Trimark Entrance Door Latch

Bulletin Type:	TSB	Publication Date:	September 2025
Bulletin #(s):	25-004	Make(s):	Entegra Coach
Job Code(s):	9803627	Model(s):	Anthem, Aspire, Cornerstone, Cornerstone Reserve
Flat Rate(s):	9803627A .10 HR - Entrance Door Latch Inspection 9803627B .30 HR - Entrance Door Latch Inspection and Repair	Model Year(s):	2025 – 2026

Incident:	Exterior Entrance Door Lock-out
Affected Units:	2025 – 2026 Entegra Coach Anthem, Aspire, Cornerstone, Cornerstone Reserve
Parts Kit:25-004EC	Parts Kit #: 25-004EC
	Part Kit Contents: 1 - KIT,TSB 100-3100 RTROF TSB102
Misc. Tools & Supplies:	Refer to Instructions below
Parts Return Information:	Serial number of door

Purpose: There is a possible condition where the exterior entrance door handle mechanism can bypass the inside linkage causing a lock-out situation whereby the door cannot be opened from the exterior handle.

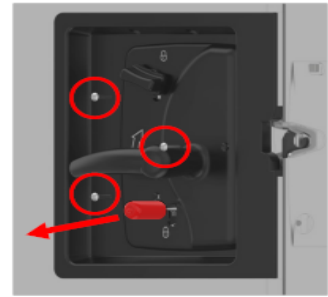
Step 4: Remove the (3) Torx Head Screws from the inside plate assembly and set aside for reuse later.

Part Number and Date Code

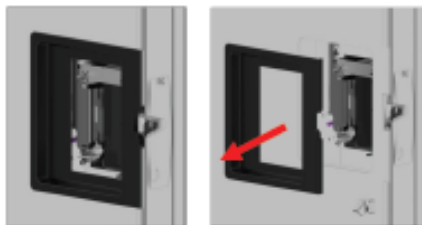
Inspect the end of the Connecting Rod. If there is a "-" mark on the threaded end, proceed to Step 7. If there is a "X" mark or a "-" AND a "." on the threaded end the hardware has already been updated, skip to Step 10b and reassemble the existing door hardware. No hardware from the kit will be needed.

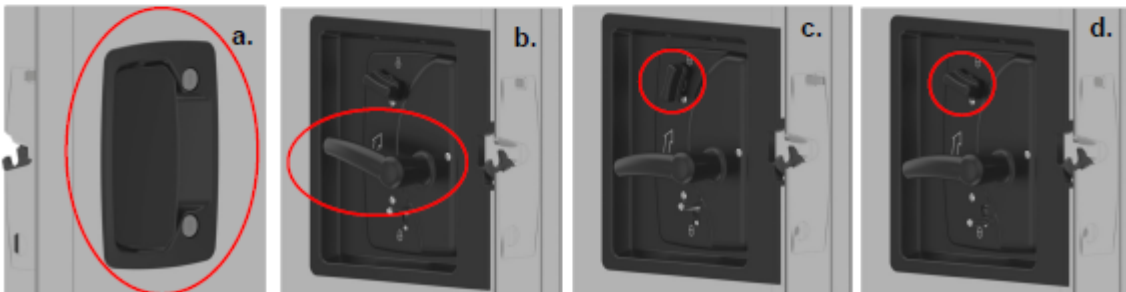
Step 11a: Lift the interior handle to make sure the system is seated properly, and the outside driving cam is behind the inside pivot plate, while pressing the inside and outside together.

Step 11b: Make sure the Upper Lock Knob engages with the "D" shaped shaft on the exterior handle.

Step 11c: Reinstall the (3) Torx Head Screws in the order listed to make sure everything is aligned correctly. Only install the screws 2-3 rotations.

Step 11d: Lift interior handle to ensure proper engagement.

Step 11e: Once all 3 screws have been installed, then torque each screw to 13 in-lbs in the same order listed. If applicable, reinstall the vinyl cap on the inside handle lock knob.

Interior View

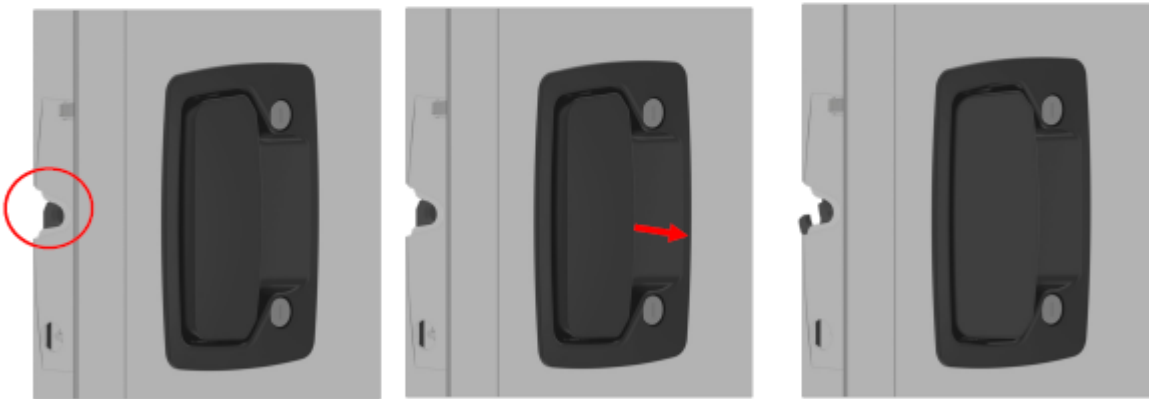
While locked, pull up on the inside handle and continue holding the inside handle up. Using a 7/16" deep well socket, manually (no power), turn the nut clockwise until the latch releases, being sure the nut is contacting the trip lever, and the nut driver is NOT contacting the trip lever. After the latch releases, let go of the inside handle and then turn the nut counterclockwise 1-1/4 to 1-1/2 turns.
